White Farm Equipment Company

Service Bulletin

Location Charles City
 Subject Transmission Oil Leakage –
 1265 & 1365 Tractors
 Number 430 713
 Date 5-8-75
 File C Transmission

Fig. 1. Upper Transmission Shaft

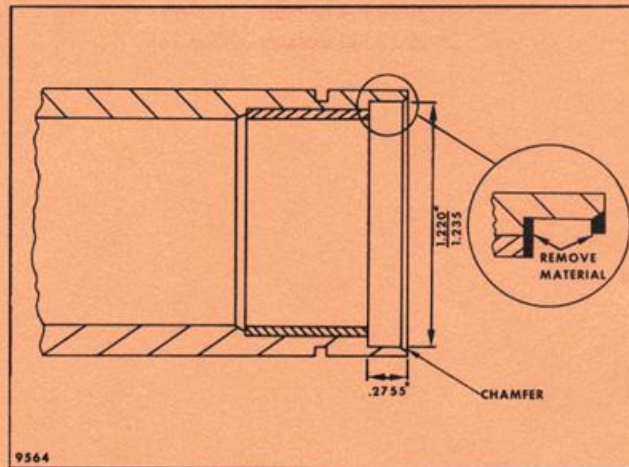
Transmission oil may travel forward along PTO shaft to engine clutch on some 1265 and 1365 tractors.

677 412A Seal may allow transmission oil to move forward along PTO shaft or seal may turn with PTO shaft permitting oil seepage between seal and transmission input shaft.

Existing 677 286AS (1265) and 30-301 1690 (1365) shafts may be reworked to accept 31-290 2578 Seal (Fig. 1). Install seal with lip toward rear of tractor.

1265 tractors after serial number 312 870 and 1365 tractors after serial number 728 082 have upper transmission shafts incorporating 31-290 2578 Transmission to Clutch Shaft Seal. 31-290 2578 Seal is pressed into shaft and has sealing lip on PTO shaft.

NOTE: If seal does not fit securely in bore, secure using sealant or 30-316 3253 Loctite (No. 271).

If upper transmission shaft requires replacement, install following shafts which use 31-290 2578 Lip Type Seal.
